Response to Memoranda + Design Adjustments

October 20, 2015

Carpionato Application # 4744

Response to Hiram's Memoranda of 10.13.2015 + 09.10.2015

Revised ACDD #1 The Park with Large Performance Space

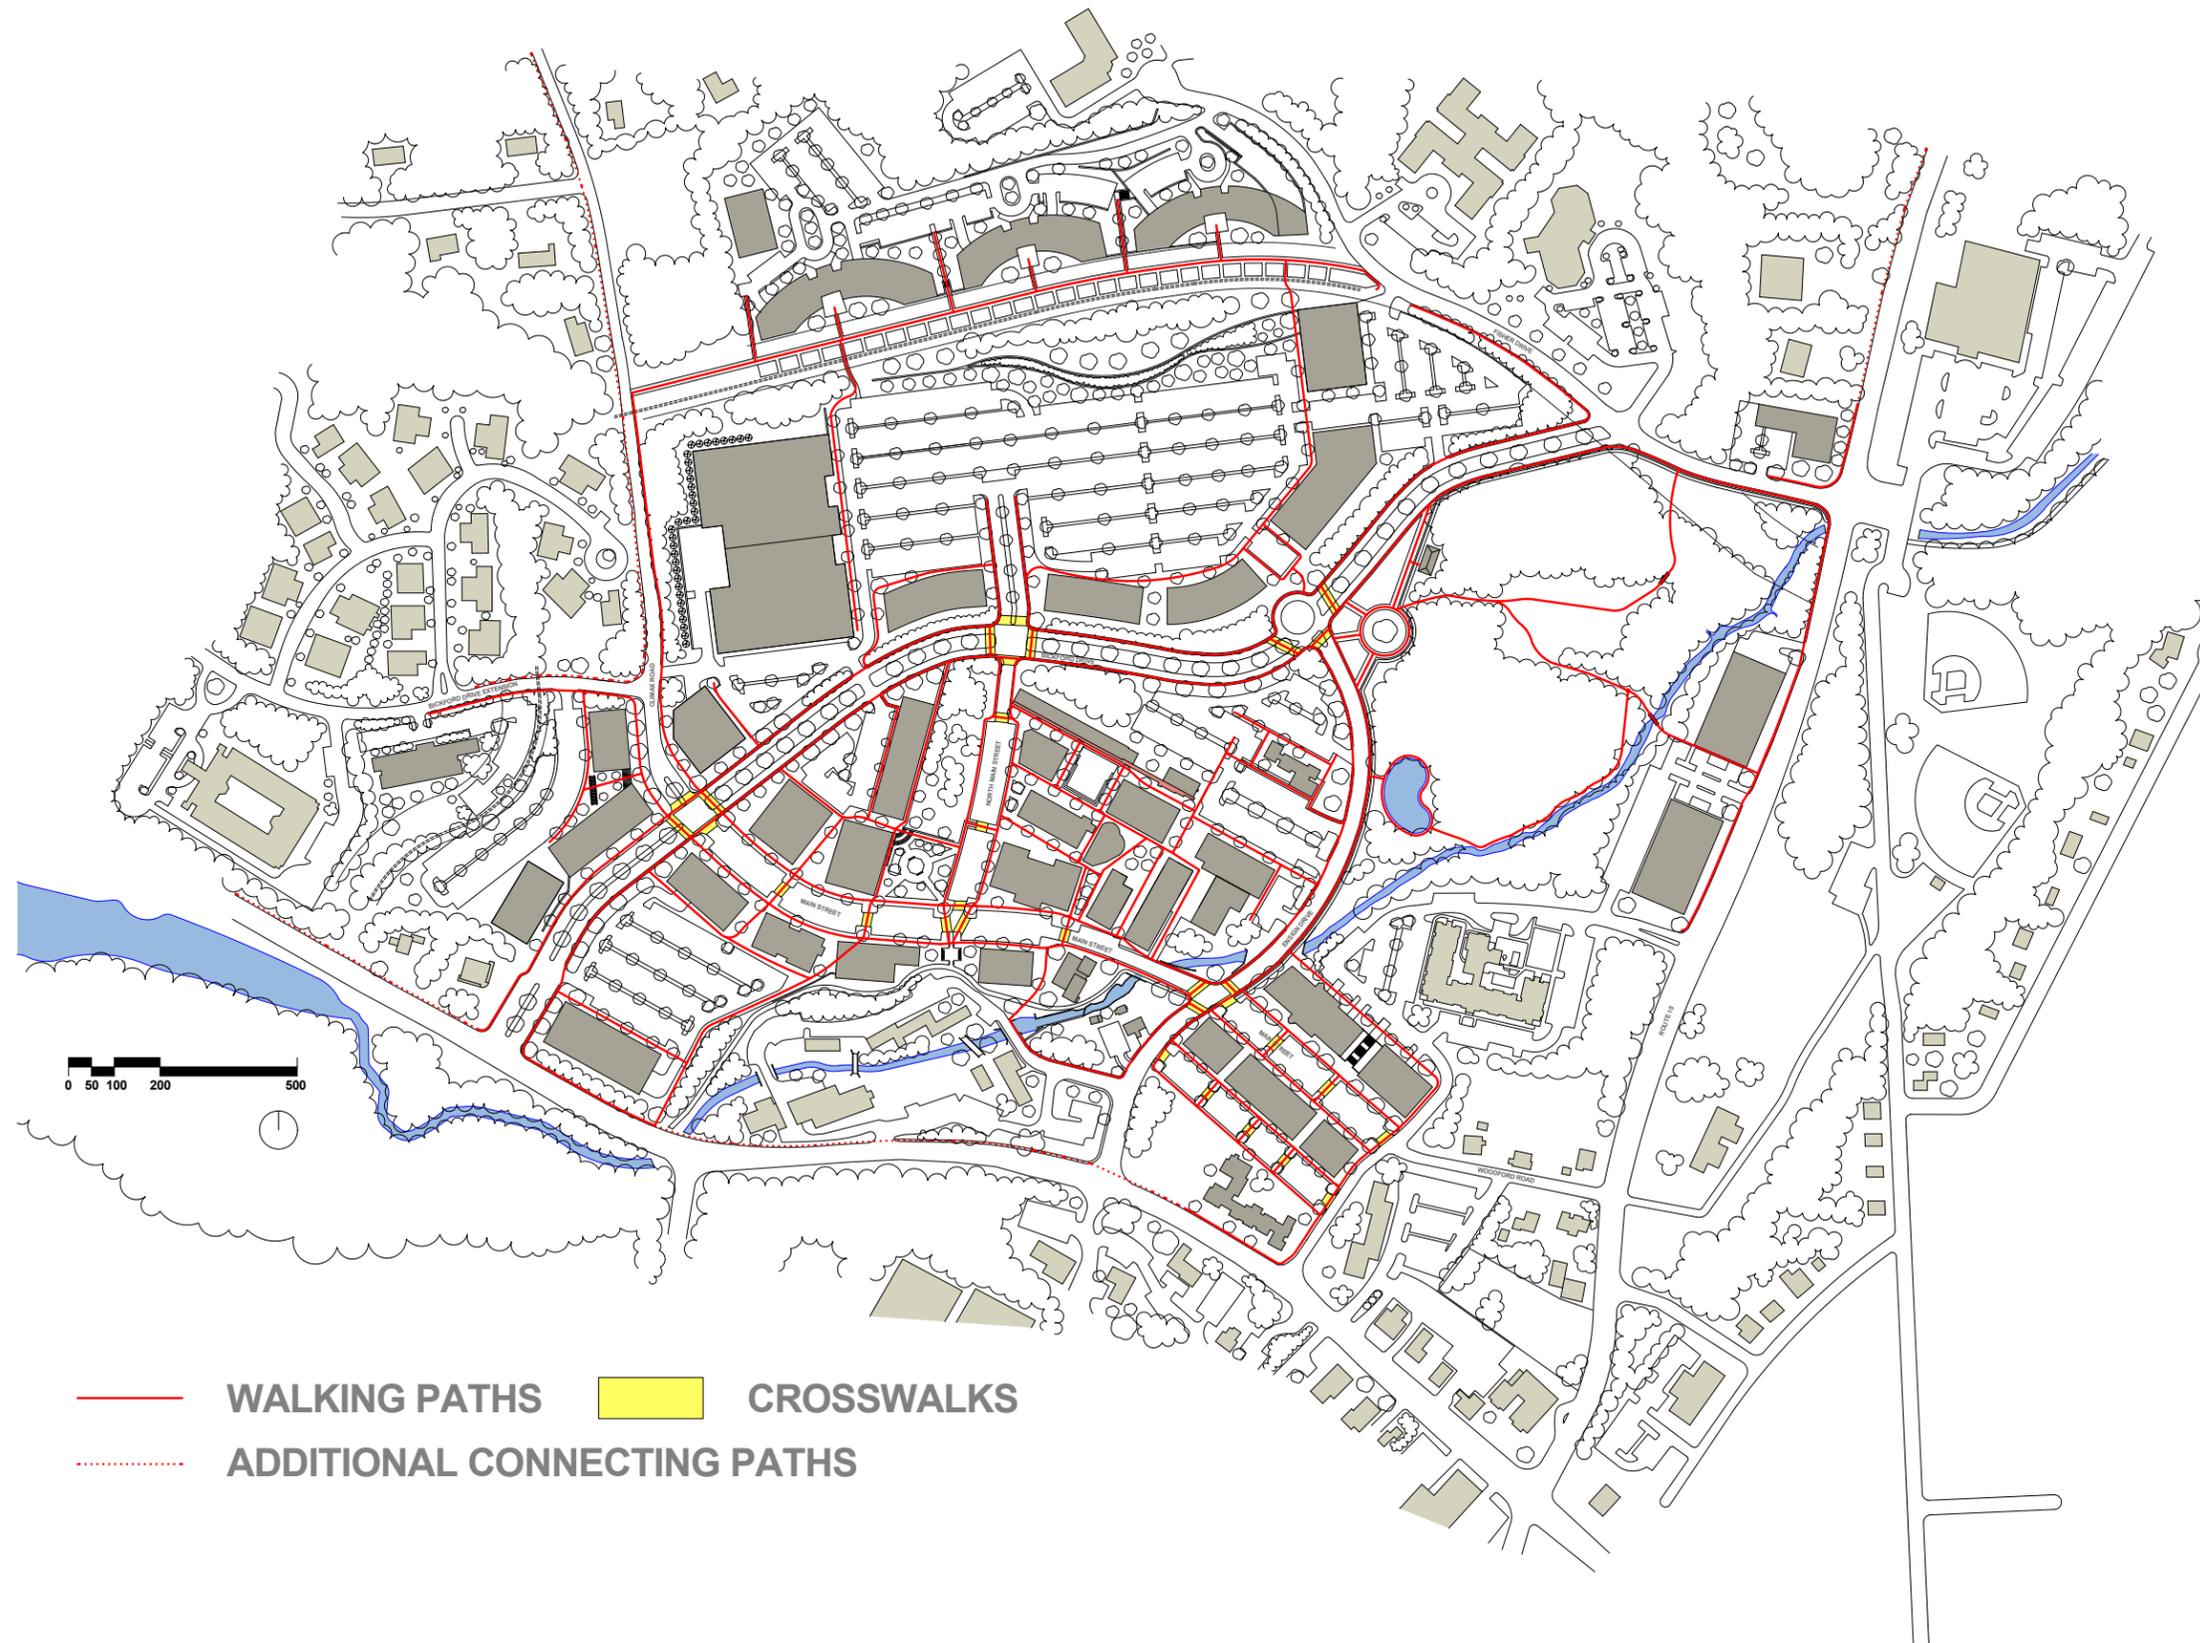
- Revised Northern Edge with One-Story Buffer Buildings and Landscape Buffer
- Emergency Egress for Fire and Police
- Expanded Bike Path System
- Expanded Sidewalk System

Walking Path/Sidewalk Expansion Into Adjacent Neighborhoods

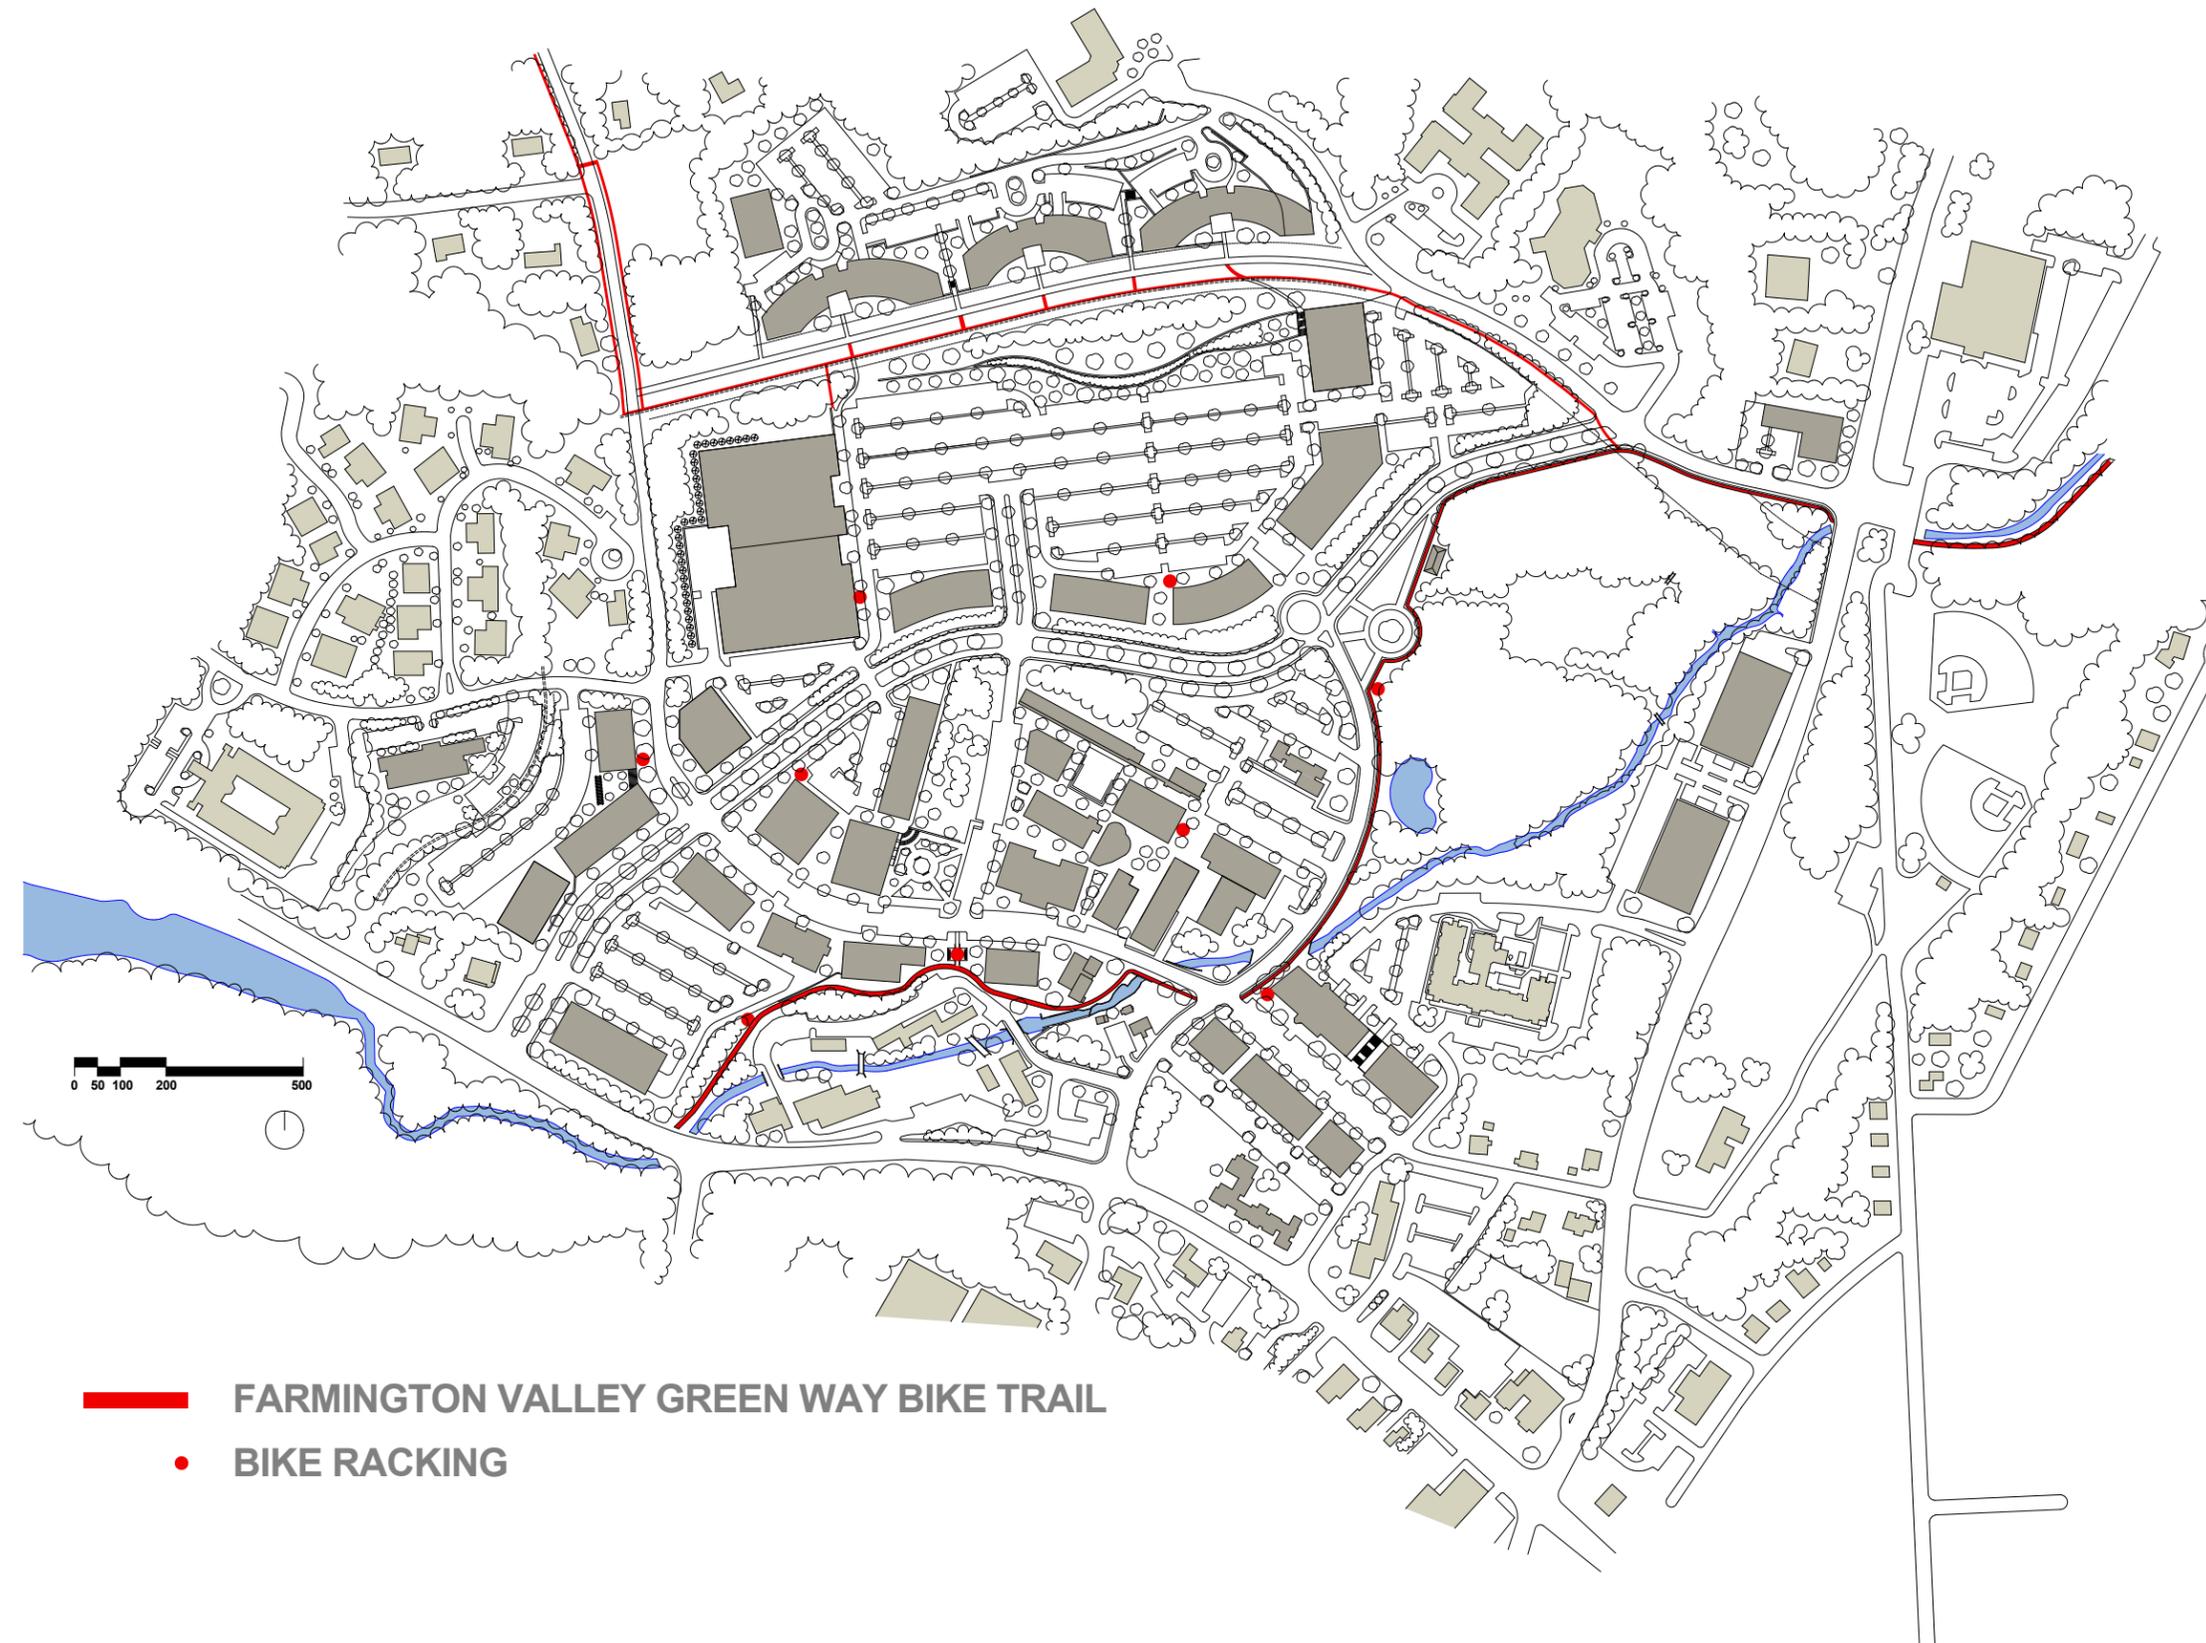
The development is intertwined with an intricate set of sidewalks and pathways that connect the various districts to each other and the buildings within each district. In addition, the Carpionato group is proposing to expand the reach of the development by building sidewalks that "reach out" into the surrounding neighborhoods. These would be located on Climax Road and Routes 44 and 10. These new and the proposed pedestrian walkways are illustrated in Appendix SIX of this document.

- a. 15% of Developable Land are as Useable Open Space.
 - b. Pedestrian walk ways. Consider the comment made as to connecting existing public buildings to the development. In addition i suggest considering for future construction, walkways to areas outside the AVC are so as to make the entire AVC area more walkable and so as to allow others to gain access to the retail and residential opportunities the development presents.
